We have read your comments carefully and have made revision. We have tried our best to revise our manuscript according to the comments: "Application of Wave-current coupled Sediment Transport Models with Variable Grain Properties for Coastal Morphodynamics: A Case Study of the Changhua River, Hainan (egusphere-2024-2154)".

Figure 6 (a) Scope of study area (the white frame) and wave observation (the red star) from Dongfang; (b) ADCP collection points on site; (c) Grids and boundaries (map origination: <https://hainan.tianditu.gov.cn/>)

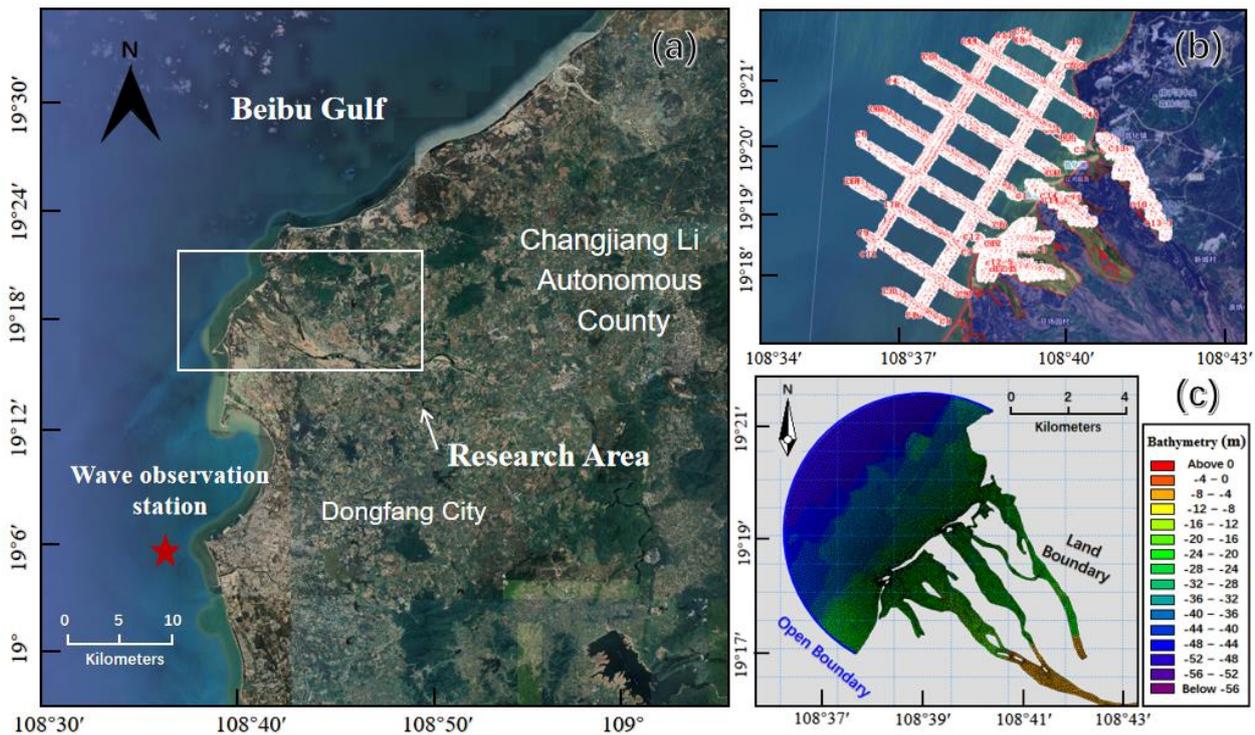
**Point 4: The model grid is not presented, is it structured or unstructured? Is it regular or curvilinear? What is the model’s resolution? The limits of the white rectangular in Figure 6 do not coincide with the grid coordinates as given in Line 280. The authors claim in lines 286-289 that the resolution of the ETOPO1 data is not sufficient for this research however it seems that these are the data used for developing the bathymetry of their model as it is written in the legend of Figure 6. The time step is also missing.**

**Correction of Figure 6:** We have revised Figure 6 to accurately represent the model grid and its boundaries. The white rectangular limits now correctly coincide with the grid coordinates, providing a clear visual representation of the model domain and its spatial extent.

**ETOPO1 Data Clarification:** We acknowledge the confusion caused by the previous description of the ETOPO1 data usage. The ETOPO1 data, with a resolution of 1 arc-minute, was indeed used as a base to develop the bathymetry of our model. However, the scope of the model is small. The model's span is 14 arc-minutes by 7 arc-minutes. Therefore, we have conducted topographic surveys using an ADCP-equipped survey vessel. The measured data have been interpolated to generate the high-resolution terrain information used in our model. The specific locations of these survey points are now clearly indicated in Figure 6.

Figure 11 Flow field inside the estuary : (a) moment of the maximum flood current; (b) moment of the maximum ebb current

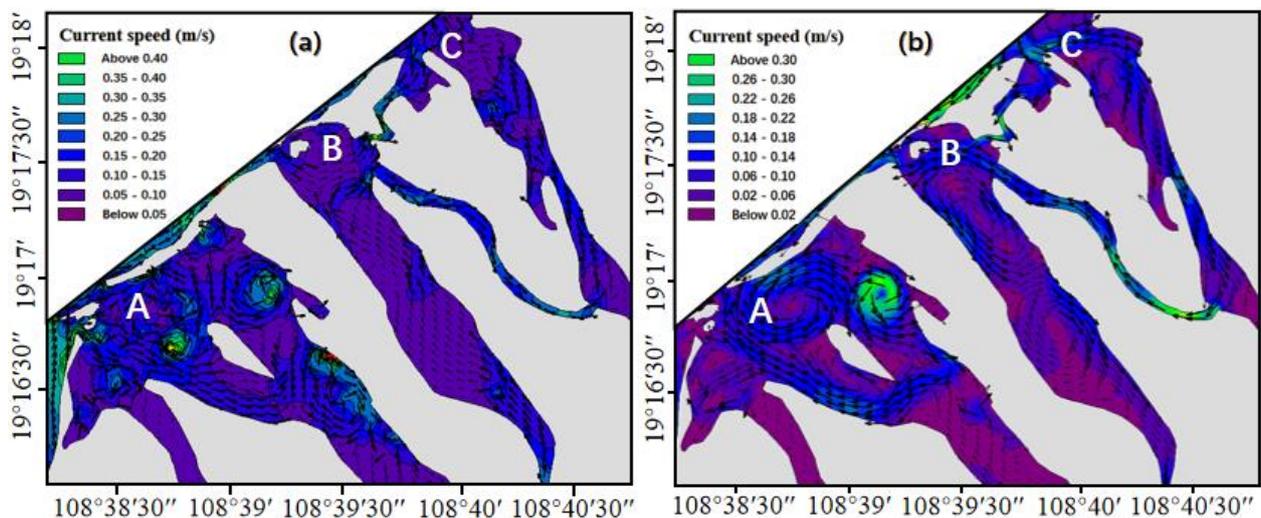
**Point 5:** The hydrodynamic results (section 3.3) are ill-presented and not adequately analysed. At which moment the results given in Figure 9 correspond to? Are these depth and/or time averaged? The depicted current of Figure 9 is in some instances referred to as a tidal (line 345) and in others as a coastal one (line 430). Are these averaged, combined tide and wave currents over this week of simulation or are taken at a certain time of calculation and if so, which one? Furthermore, it is written that the results are given at the times of high and low water but tidal currents at these times are minimal. What's the situation at slack times? Finally, there is no mention in the manuscript of whether we are looking at a period of neap or spring tide. Water levels in Figure 7 remain almost constant during the simulation period and in any case a spring-neap cycle takes place within 15 days and not one week (lines 473-478).

timing of the results presented in Figure 9. We have now specified that Figure 9 corresponds to the peak flow moments during both ebb and flood tide cycles, which occur at the transition phases between high and low tide. The revised part now reads as follows:

“Figures 11a and 11b illustrate the flow field inside the estuary of the Changhua River. Figure 11a shows the flow field at 23:00 on April 23, 2023, corresponding to the peak of the flood tide. Inside Estuary A, due to the topography, a large counterclockwise circulation forms around the central island, accompanied by several smaller vortices, with the overall trend of tidal currents flowing southeast along the river channel. In Estuary B, ocean inflows meet with river flows from upstream, ultimately converging into Estuary C through the passage between B and C. In Estuary C, the flow is more unidirectional compared to A and B, with upstream water flowing into the ocean, then following the northeast-directed tidal current outside the Changhua River estuary. Figure 11b shows the flow field at 13:30 on April 24, 2023, at the peak of the ebb tide. At this time, the circulation inside Estuary A reverses to a clockwise direction, and other smaller vortices change direction accordingly, with the overall trend of tidal currents flowing from upstream to the ocean. In Estuary B, the dominant force is the high-speed flow from Estuary C, which enters B through the narrow passage between B and C, splitting into two opposite directions: one part flows into the ocean, and the other flows upstream, forming a circulation within the river channel. In Estuary C, the water flows upstream from the ocean along the river channel.

Figure 13 Selection point for sediment deposition verification ”

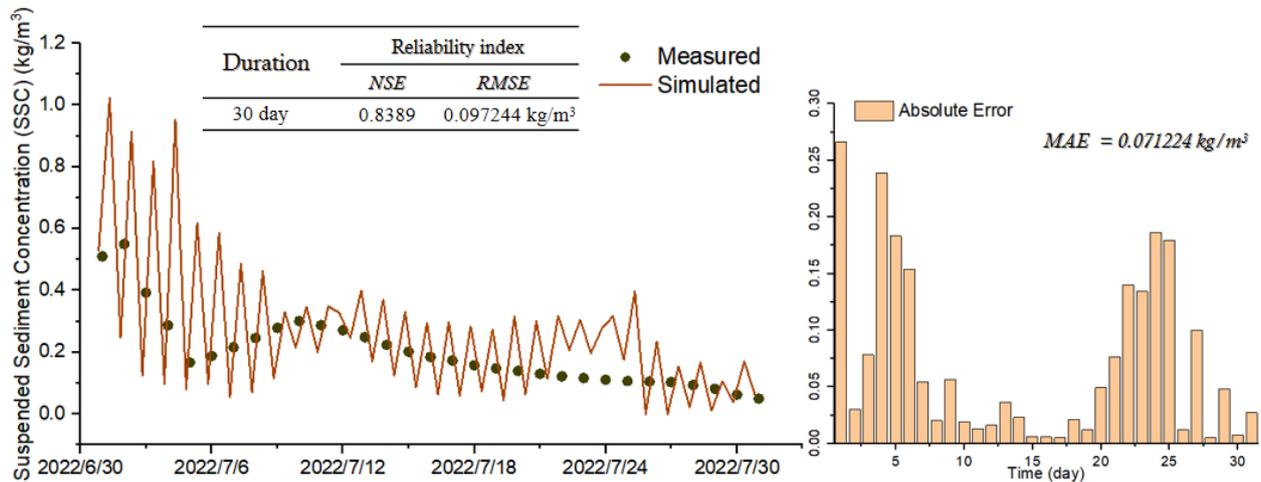
**Point 9: The authors calculate a uniform over space sediment thickness from their model equal to 4.1 cm. If what they write in lines 365-366 is right, then they get results after the one-week simulation that they did for 23/04/2023-30/04/2023. But then they use the estuary’s sediment discharge of 2022 (line 389-390) and they compare their model result with field data covering one month (July 2022)!! Not surprisingly then, there is a serious discrepancy of 1.1 cm between the model and the observations which is too big to be ignored. Besides, the assumption that the uniform over space result from a one-week simulation for a certain year can be representative of any year for that specific area is too crude.**

*To further analyze the simulation validation, Figure 13 presents a histogram of the daily absolute error in SSC at Baoqiao Station. The absolute error is calculated as the absolute difference between the measured and simulated values. The Mean Absolute Error (MAE) is defined as the average over the test sample of the absolute differences between prediction and actual observation. The MAE in SSC for Baoqiao Station in July is 0.071224 kg/m<sup>3</sup>. The maximum error occurs at the beginning and the end of the month, which may be due to the use of monthly average flow and sediment data for the model's upper boundary input, thereby increasing the model's error. Overall, the difference between*

Figure 6 (a) Scope of study area (the white frame) and wave observation (the red star) from Dongfang; (b) ADCP collection points on site; (c) Grids and boundaries (map origination: <https://hainan.tianditu.gov.cn/>)

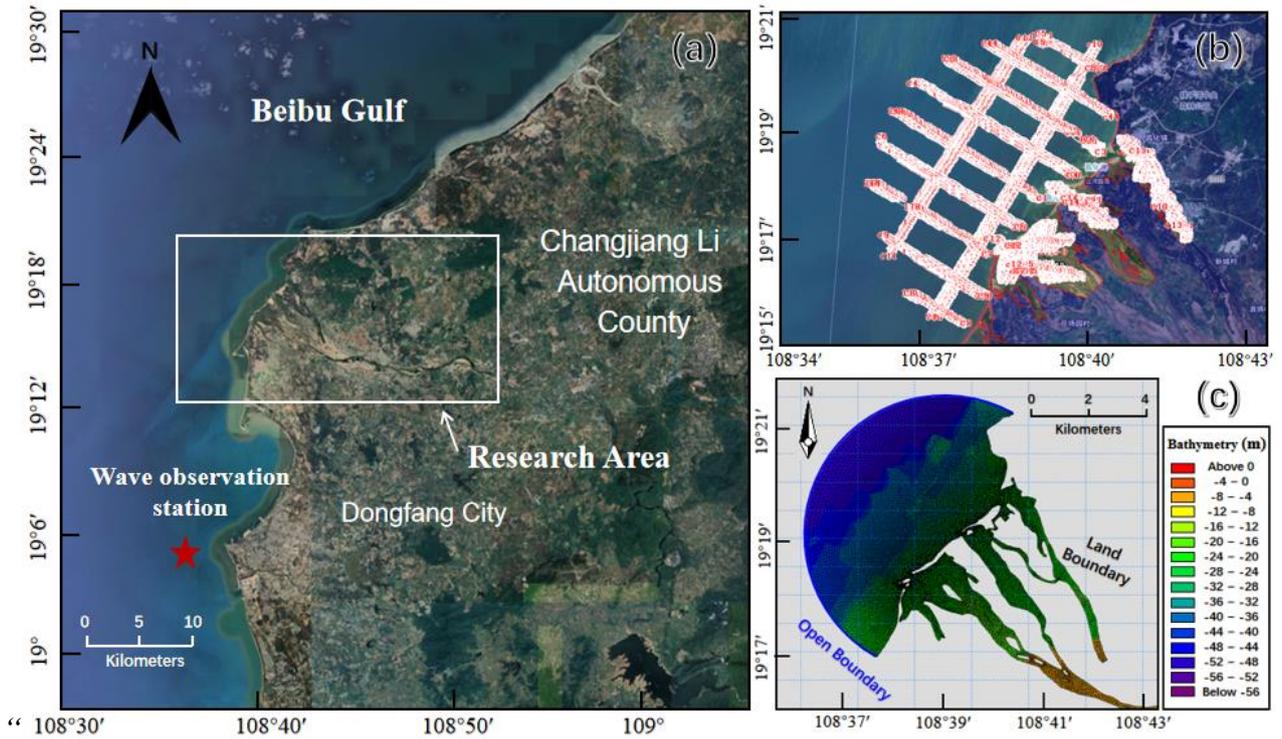
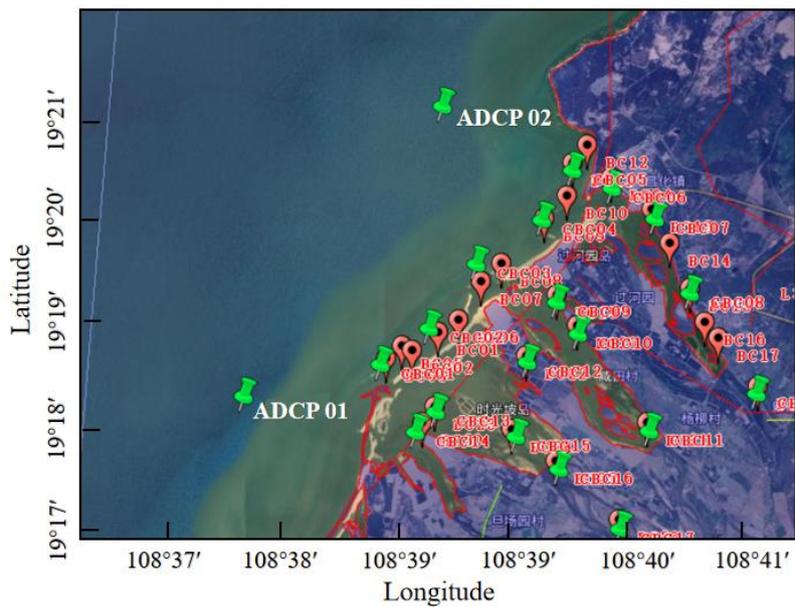
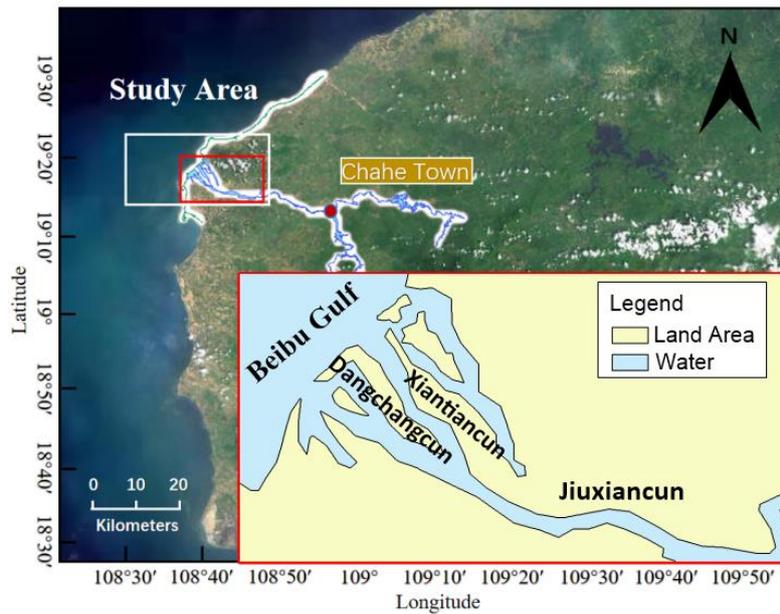
**Point 11: In their figures, the authors fail to provide all the necessary information regarding their study case. They refer to stations that can be nowhere found in their figures and so the reader cannot understand from which location the results and data are taken? Specifically, Dongfang Ocean station, Danchangcun, Xiantiancun and Jiuxiancun stations cannot be found in the figures. The same for the ADCP.**

**Response:** We appreciate your feedback regarding the clarity and comprehensiveness of our figures and the corresponding descriptions in the manuscript. We understand the importance of providing detailed and accurate geographical information to ensure the reader's full comprehension of our study. In response to your comments, we have now included detailed maps with clear labeling of all the stations mentioned, including Dongfang Ocean station, Danchangcun, Xiantiancun, and Jiuxiancun, as well as the ADCP locations. These maps are incorporated into the relevant sections of the manuscript and are referenced within the text to guide the reader.

Figure 20 Eulerian residual current field during low water period

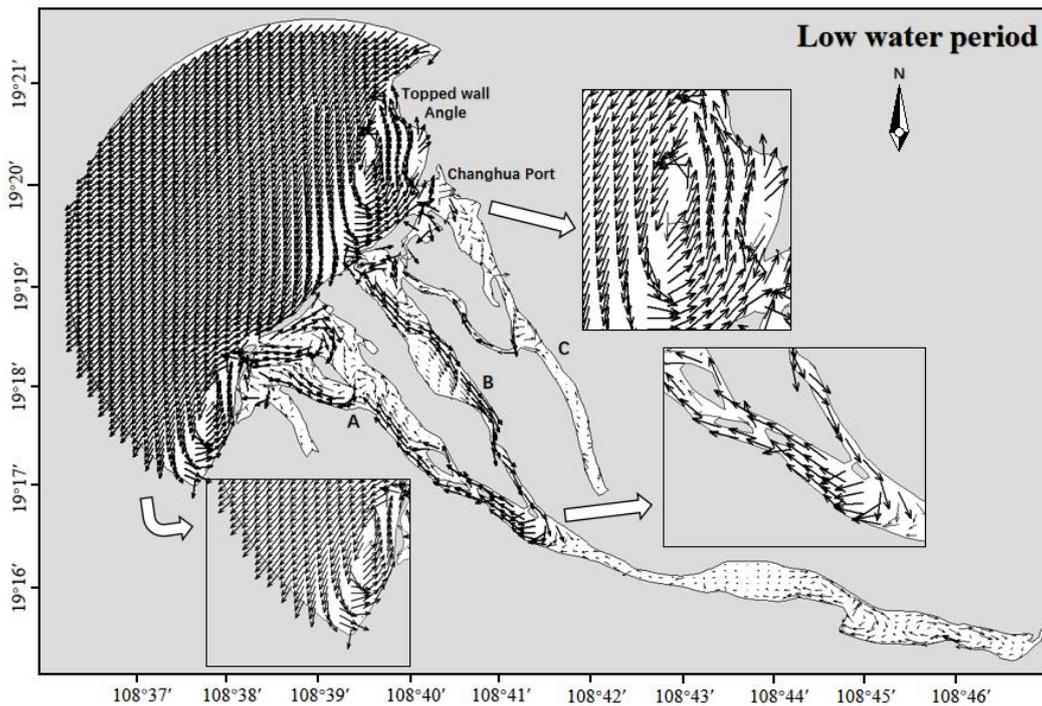
**Point 12: Chapter 4 does not discuss the scientific output and fails to explore and highlight the importance of the outcomes. It only provides a list of potential measures to be taken against siltation which have only a local interest. These can be hardly supported considering that they are based on conclusions from not adequately justified modelling. I suggest that the authors rewrite this section after they have addressed all the raised issues in their modelling approach but from a non-local perspective.**

*the Eulerian residual currents within the study area in a complete and clear manner; a limit on vector length was set when plotting the current field. Consequently, the direction and length of the arrows in the figure represent the direction of the residual currents, but not their intensity. However, the intensity of the Eulerian residual currents can still be discerned through the data at the grid points. The Eulerian residual current outside the Changhua River estuary generally flows southward. As it flows from north to south, it is obstructed by the sand spit, diverging around it. After the divergence, the southwestward Eulerian residual current splits, with one part following the sand spit to the river mouth near A, and the other part entering channel B and flowing inward. The northeastward Eulerian residual current, after divergence, encounters the obstruction of the headland (Topped wall Angle) and forms a counterclockwise circulation below Junbi Jiao. Headlands are one of the key topographical features where strong residual current vortices occur (Maddock et al., 1978; Pingree et al., 1977; Smith, 2010). At the headland, the water depth shoals in the onshore direction, and the frictional effect is stronger in shallow water areas than in deep water areas. This results in a frictional force moment on the alongshore tidal current, generating vorticity. The transport of vorticity within the closed circulation lines on either side of the headland is not equal in input and output. After a tidal cycle of time averaging, a net vorticity will be produced on both sides of the headland, forming two counter-rotating residual current vortices, with the tidal residual current at the tip of the headland generally pointing seaward (Zimmerman, 1981). Topped wall Angle, being a headland, can produce similar residual current field results. A clockwise residual current vortex opposite to the one below may exist above Topped wall Angle. The Eulerian residual currents in the three river channels where A, B, and C are located all flow towards the river mouths. The Eulerian residual current in the channel between B and C flows from B to C.*

Figure 5 Variation of sediment particle size data (map origination: <https://hainan.tianditu.gov.cn/>)

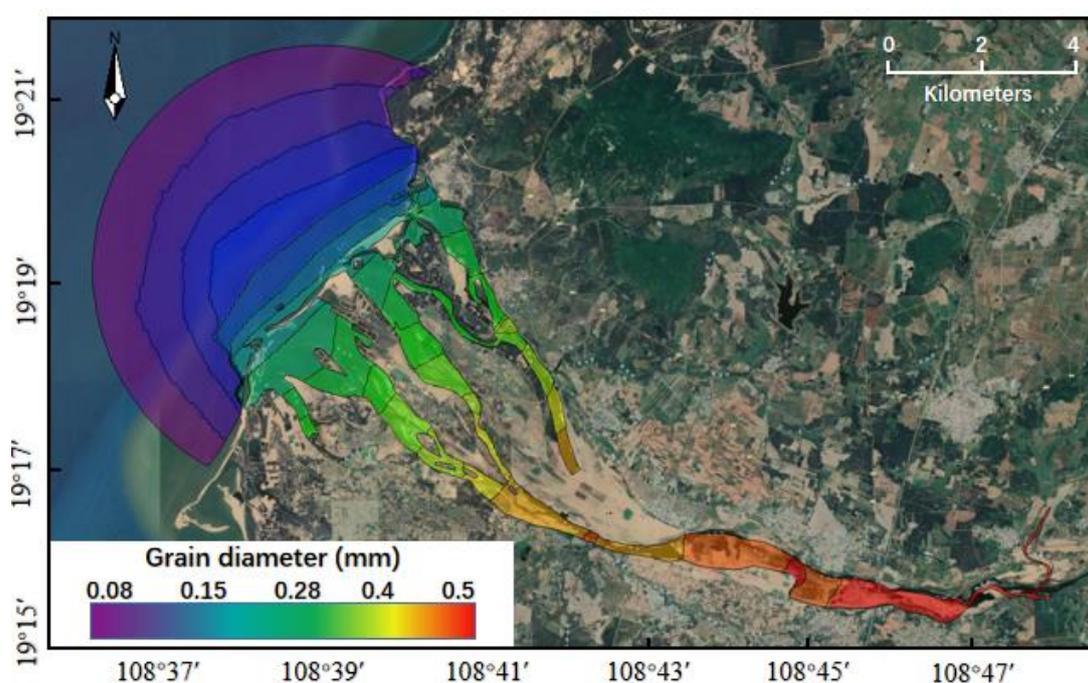
**Point 17: Line 241, the range expression for gravel (>2 mm), sand (2~0.063 mm), silt (0.063~0.004 mm) is problematic; the larger value should be placed after the smaller value. The legend of Figure 5 lacks units.**

Response: Thank you for your comment on Line 241 and the legend of Figure 5. In response to your feedback, I have corrected the range expression for gravel ( $>2$  mm), sand ( $0.063\sim 2$  mm), and silt ( $0.004\sim 0.063$  mm) to ensure that the smaller values are placed before the larger ones, following the standard notation for size ranges. Additionally, I have updated the legend of Figure 5 to include the appropriate units, ensuring that all information is clear and accessible to the reader. I believe these amendments address your concerns and improve the precision and readability of the manuscript.

Figure 6 (a) Scope of study area (the white frame) and wave observation (the red star) from Dongfang; (b) ADCP collection points on site; (c) Grids and boundaries (map origination: <https://hainan.tianditu.gov.cn/>)

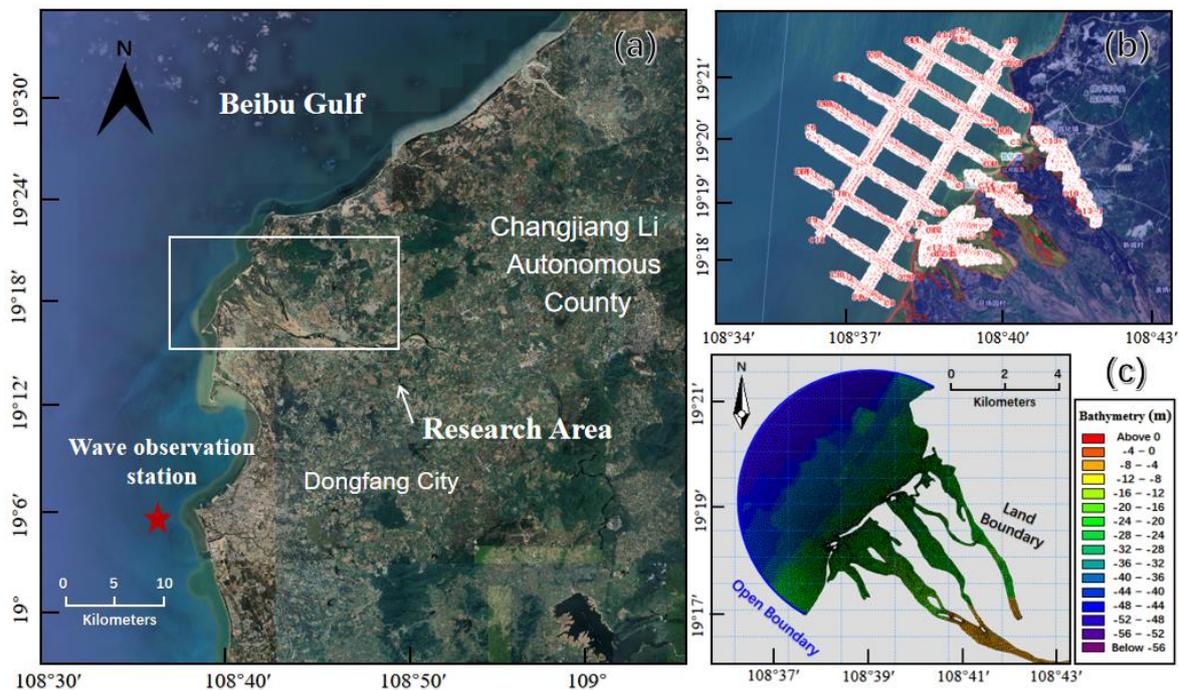
**Point 18:** The scope of the study in Figure 6 is not consistent with the description in Line 280; it is recommended to modify it. Additionally, according to the geographical location of the Changhua River, it is located in the southwest of Hainan Province, but it is described as the western part in Line 278? Line 287, how is the elevation measured by ADCP obtained? Can specific information about the survey vessel be provided to increase the credibility of the article's data?

**Figure 6 Scope Consistency:** I have revised the scope depicted in Figure 6 to align with the description provided in Line 280.

*Figure 10* Study area and coastal current direction: (a) location map of the study area; (b) detailed zoom of the map in [Fig. 9a](#) with NE current; (c) detailed zoom of the map in [Fig. 9a](#) with SW current. (map origination: <https://hainan.tianditu.gov.cn/>)

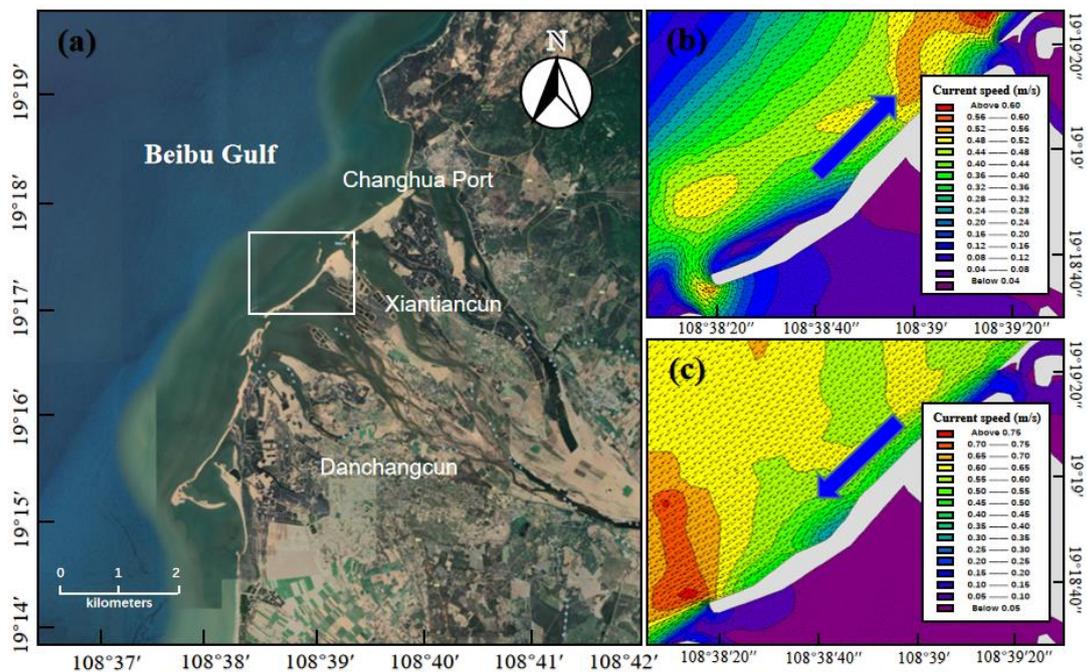
**Point 20: Section 3.3 lacks analysis of the hydrodynamic results, and the description of the hydrodynamic environment of the study area is insufficient. It is recommended to expand the text and analyze it in conjunction with the sediment transport model.**

“The hydrodynamic simulation outcomes, as depicted in [Figure 10](#), indicate a predominantly NE-SW reciprocating current pattern within the study area. This flow is aligned parallel to the coastline, with the tidal current shifting direction according to the tidal phase. [Figure 10b](#) and [10c](#) depict the flow field outside the estuary of the Changhua River. [Figure 10b](#) shows the flow field at 23:00 on April 23, 2023, corresponding to the peak of the flood tide. At this time, the tidal current flows in a northeast direction with a maximum speed of 0.62 m/s. [Figure 10c](#) shows the flow field at 13:30 on April 24, 2023, corresponding to the peak of the ebb tide, where the tidal current flows in a southwest direction with a maximum speed of 0.75 m/s. Overall, the tidal currents outside the Changhua River estuary generally follow a northeast-southwest reciprocating pattern, with flood tides flowing northeast and ebb tides flowing southwest, parallel to the shoreline. The maximum ebb current is faster than the maximum flood current.
